**231 Whale Beach Road, Whale Beach NSW 2107**

**TRAFFIC AND PARKING IMPACTS REPORT  
FOR A DEVELOPMENT APPLICATION  
FOR A PROPOSED MIXED USE DEVELOPMENT  
AT No. 231 WHALE BEACH ROAD, WHALE BEACH NSW 2107  
for the purpose of a Section 8.2 review**

<b>Property address</b>	231 Whale Beach Road, Whale Beach NSW 2107
<b>Client</b>	Richard Cole Architecture Pty Ltd
<b>Prepared by</b>	O. Sannikov, MEngSc (Traffic Engineering), MIEAust, PEng, FAITPM
<b>Date</b>	06/08/21
<b>Job No.</b>	21078
<b>Report No.</b>	21078 Rep 01

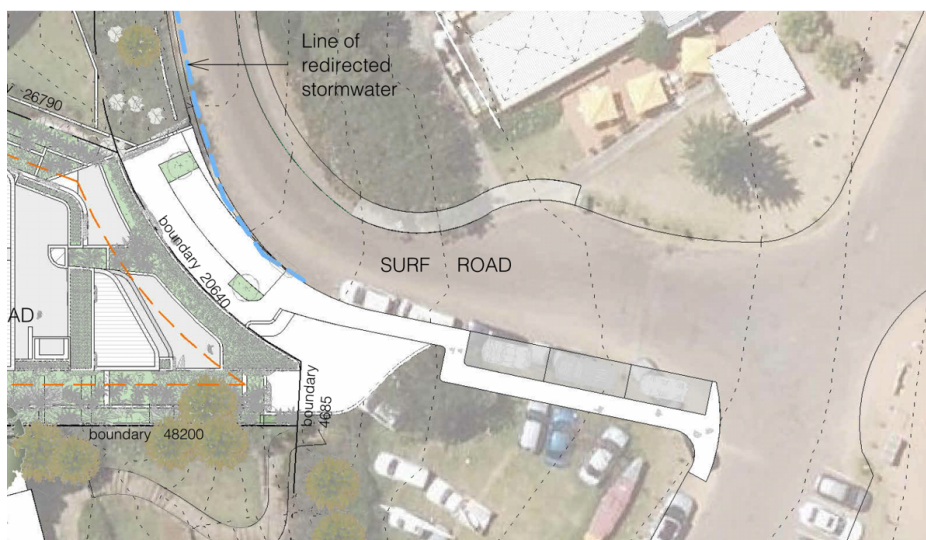
- Matter 7**
- **TERR MM**
    - *- Realignment of kerb between the access driveway to the basement car park and The Strand*
      - *The section of Surf Road between Whale Beach Road and The Strand is narrow and the road width varies from 5.5 from the northern end to 7m. Parking is restricted on both sides of the road except for the section located immediately east of the existing driveway where parallel parking is permitted for approximately 3 vehicles. The access driveway to the basement car park is located on the bend in Surf Road and existing parking narrows the road and obstructs sightlines for vehicles exiting the site. The kerb realignment should retain parking for 3 parallel vehicles and provide a 6m road width for two-way traffic.*

- Response**
- The proposal features kerb realignment and three indented car parking spaces as requested (refer to a drawing below).
